A NEW BRANCH FOR: MATTHEWS

RE: Addressing Comments

Charlotte Metro Credit Union Proposed Branch

Zoning Application 2013-607/Charlotte Metro Credit Union: To change the existing conditions in that certain B-1(CD) zoning district located at 435 N. Trade Street to reduce in size the approved office building and to allow a two-lane drive-through and an ATM unit; eliminate the pre-approved driveway connection at N. Trade Street; and to allow construction of a neighborhood pocket park.

LAND USE SITE PLAN

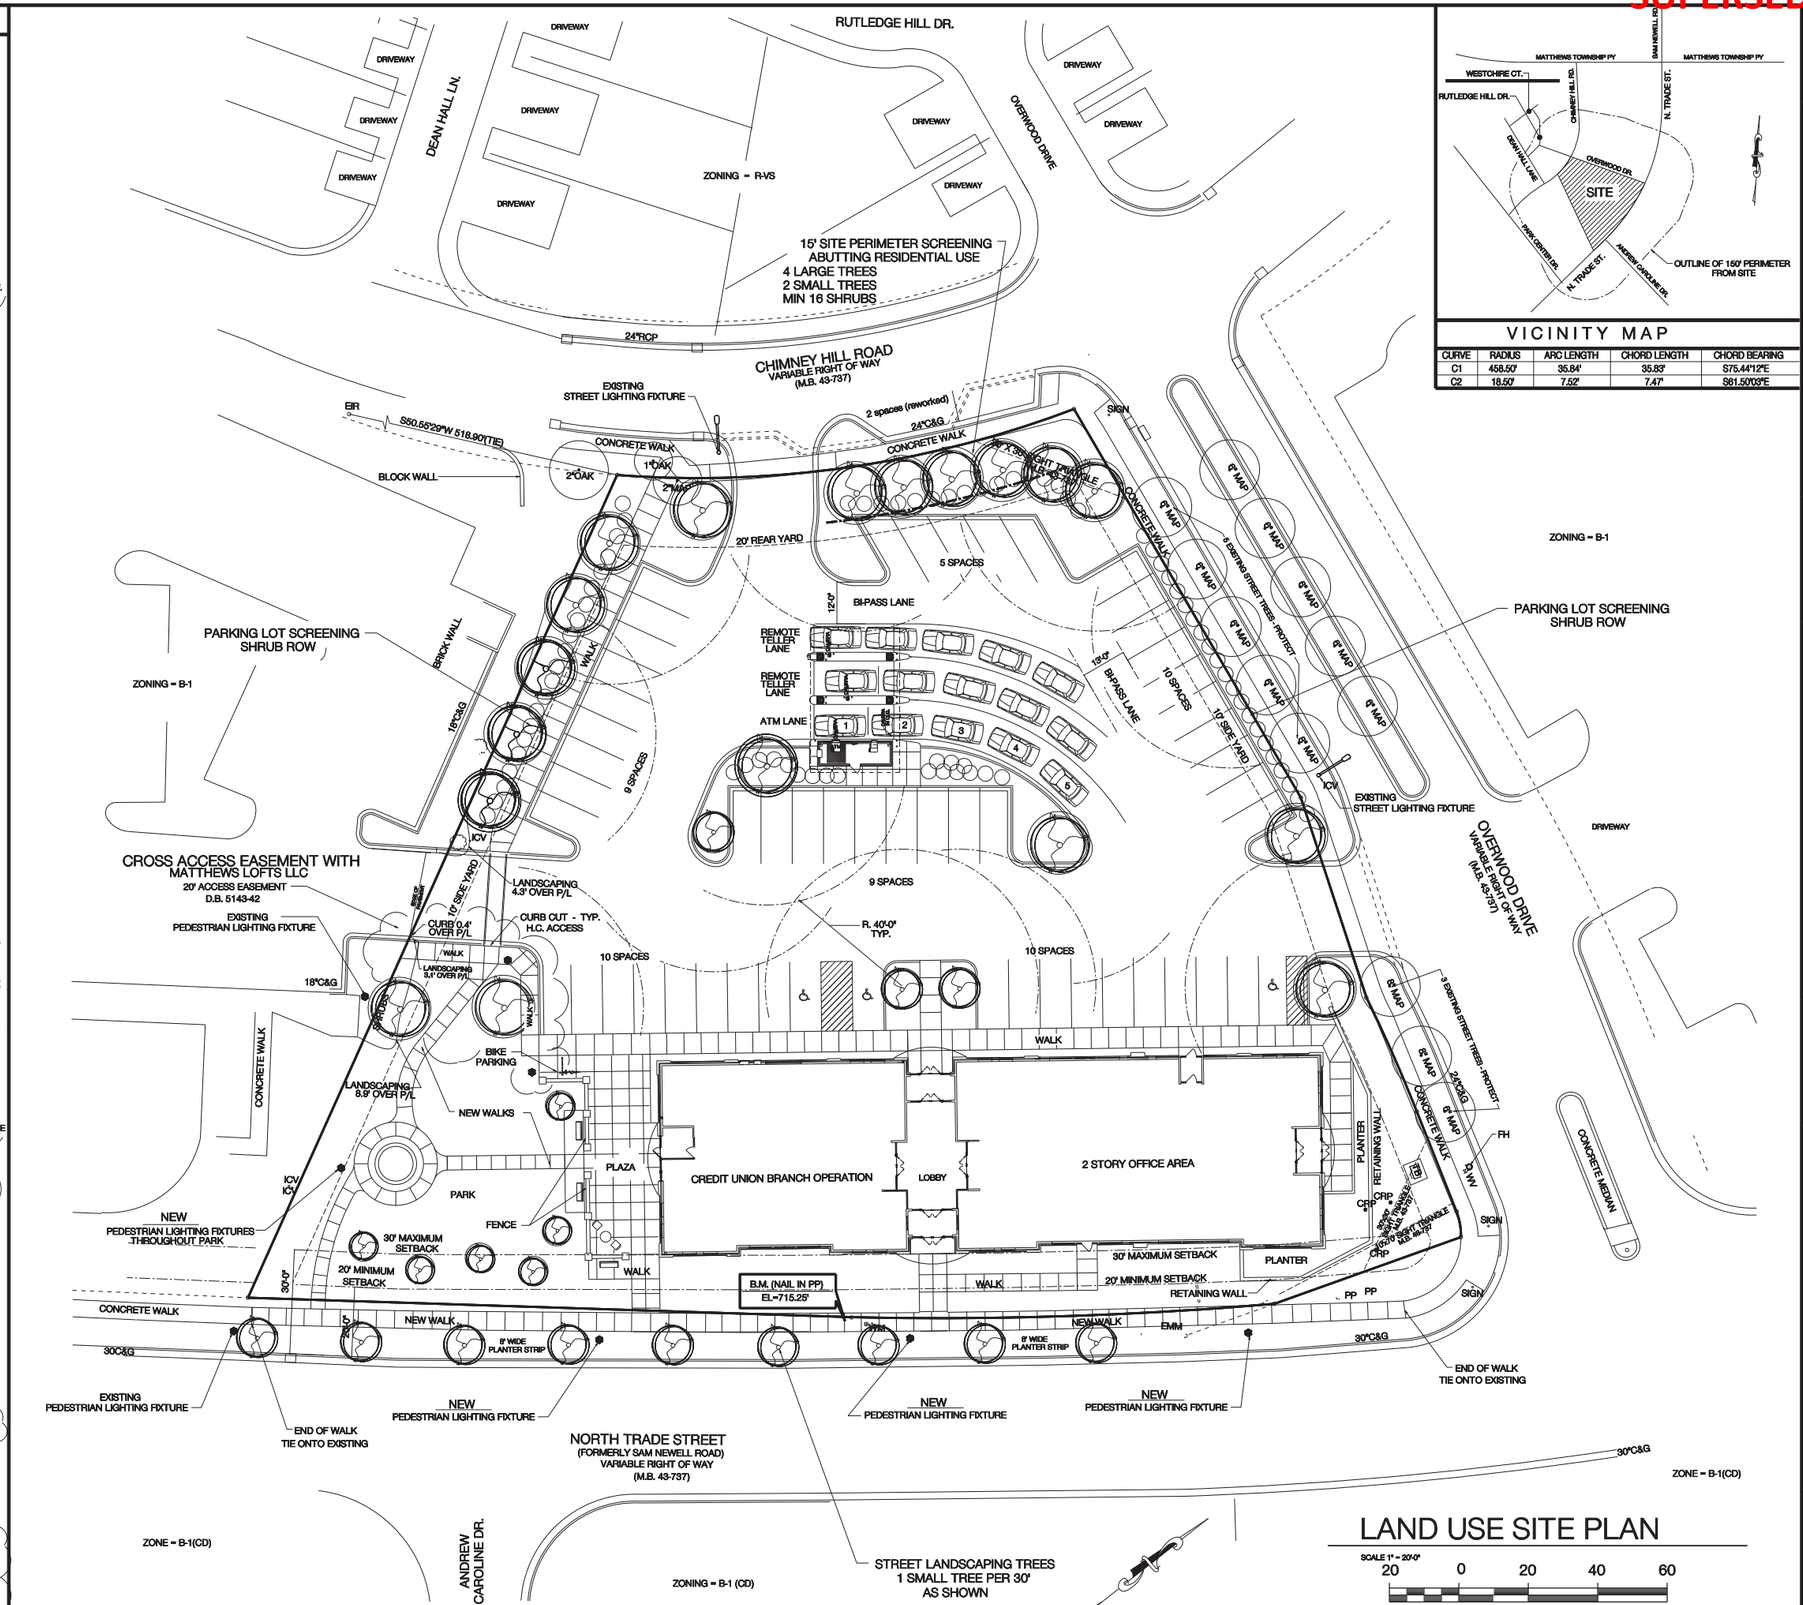
Outstanding staff comments include the need for more clarification regarding ownership and allowed public usage of the park space. As proposed it would be private space so staff would like to clarify the hours of operation, usage, maintenance and other details. There is a planter retaining wall shown on a corner of the site plan. Staff would like more detail on that design.

The sidewalk connection on the west side of the site needs a better connection to the adjacent North End development to create a continuous sidewalk along the back alley between developments. The sidewalk to the rear of the property at the back of curb should be located right on the property line to allow for more greenery and plantings to create some shade in that area of the site. There are issues with the number of signs depicted on the elevations. There is also a note about buried utilities – there is one communication line across that front that warrants being buried. Staff acknowledges that the Duke power lines that cross the street in two places would likely be difficult to bury.

Mr. Miller asked about the difference between bank drive-throughs, which are allowed in downtown, and fast food drive-throughs which are not. Mr. Camp explained that the zoning code allows accessory access drive through lanes such as those for banks and pharmacies in downtown but food uses are kept in the B-2 district due to the amount and type of use of each style. There are generally more concerns about volume and hours of use with food-related drive through uses. In addition, there are safety issues to consider with banks – if an ATM is not located in a very busy area then it is seemingly safer to use a drive-through ATM instead of a walk up ATM.

Notes have been added under Conditional Use Notes to generally describe the construction materials of the park. The park will be open for public access during all normal park and recreation hours, and additional hours as deemed desirable by Parks and Recreation. It is not intended that the park hours be restricted. Additional requirements will be as negotiated as desired by the Town. The retaining planter on the right end of the building is a step down from the current existing grade and is needed to create a level building pad the length of the building. It is not visible above existing the grade level, steps down 2' into a landscaped planter, and another 2' to the sidewalk entering the building. All exposed walls will be brick to match the building.

The sidewalk connection can be worked out with the adjoining property owner and will be extended to the property line as requested. We have shown it on our revised site plan, but it is subject to move to an agreed upon point to adjoin the neighboring property owner. The sidewalk to the rear of the property has been widened to allow pedestrian passage in front of any vehicles parked at the curb. There is a rather steep bank up to the adjoining property along this walk which makes it not feasible to move the walk to the property line. From the back side of the walk there is about a 3 to 1 gradient to the property line which is envisioned as a plant strip with trees and ground cover as indicated on the drawing. Signage will comply with Town ordinances. Discussions with Duke Energy indicate that power will be served underground from an existing pad mount transformer between the site and the North End Building. They do not plan to and are not receptive to relocating the primary feeders along Trade Street. Discussions have started with Windstream regarding the communication lines and service. Charlotte Metro will make every possible effort to have the overhead communication cables remove as a part of the service discussions. This is all that can be done at this time.

Stacking diagrams have been added to the site plan to better illustrate that traffic will not be impeded, and will be further discussed with Chief Hunter.

There was discussion at the neighborhood meeting and notes have been added to the Conditional Use notes that the parking can be used during non-business hours by the neighbors, for park access, and for community events and festivals.

SHEET NO. A-3.0

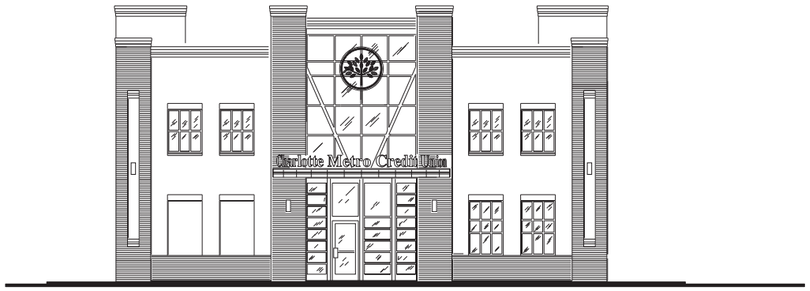
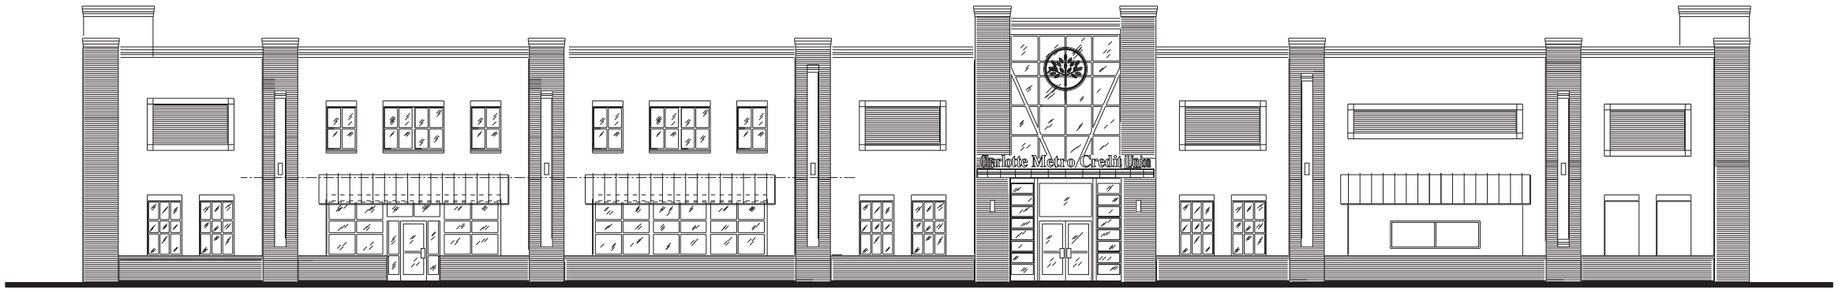
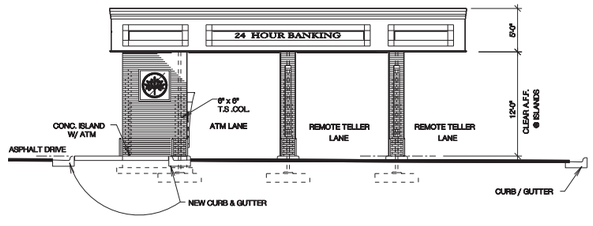
The Downtown Master Plan generally calls for more vertical development downtown with a mix of usage and higher usage of land. This application proposes a one story building and staff would like to see a two story structure implemented similar to the original plan. Staff is aware of some possible soil issues at the site and the applicant has more information on that. There could be some issues with two story construction but without further specific knowledge staff's general recommendation is for either a two story building or a two story design in appearance.

Mr. Melton said he thinks the renderings do the project justice. The black and white elevations are much more detailed but that information isn't duplicated on the rendering. He would like to see more detailed renderings and information on the retaining wall in particular.

Mr. Query said this plan calls for a small building on a large piece of land. The Town intended that to be higher density to help the downtown succeed. People are needed there, not just land. He is worried that the single story structure won't do what was in mind and thinks it should be a multistory building instead. He said the proposed building is attractive and that doesn't mean the Board doesn't want the credit union here, but that vibrancy is needed in this area.

Mayor Taylor said he would like to see something more substantial of the corner south of Highway 51. It's a low spot and it seems like something more substantial could be a better fit.

There has been much discussion with Charlotte Metro regarding the construction of a two story building. The elevations of the building have been revised to reflect a two story building. The intention currently is to construct approximately 3000SF on the second floor. Preliminary study is continuing to determine costs and structure for allowing a full second floor at the offices which would bring the second floor area to about 6000SF. The increase of the maximum building area to 17,000SF plus the drive thru includes a space allowance for the full second floor. Attached to this letter is a copy of summary sections of the geotechnical report which indicate the soils and foundation recommendations.

The renderings are being revised to try to better convey the actual topography and landscape features that will be present. The revisions will also convey the two story look of the proposed changes.

These thoughts have been taken into consideration by the Credit Union and revised the design into a two story structure. The proposed building is a maximum of 17,000SF plus the 1,150SF drive thru. The proposed building will house up to 40 employees and represents a huge investment and a stable, viable, long term commitment to the downtown by a permanent business fixture in the Mecklenburg County community. It will bring an average of 424 transactions into downtown per day (22,879 since January 1 at the existing branch). Many of those customers then being funneled directly into the North End and the downtown and can be expected to create a new untapped dynamic customer base for the restaurants and businesses in the downtown.

The building profile has been increased to address these concerns. The building location is actually not in a low spot and the floor elevation will be very close to the floor elevation of the North End building next door.
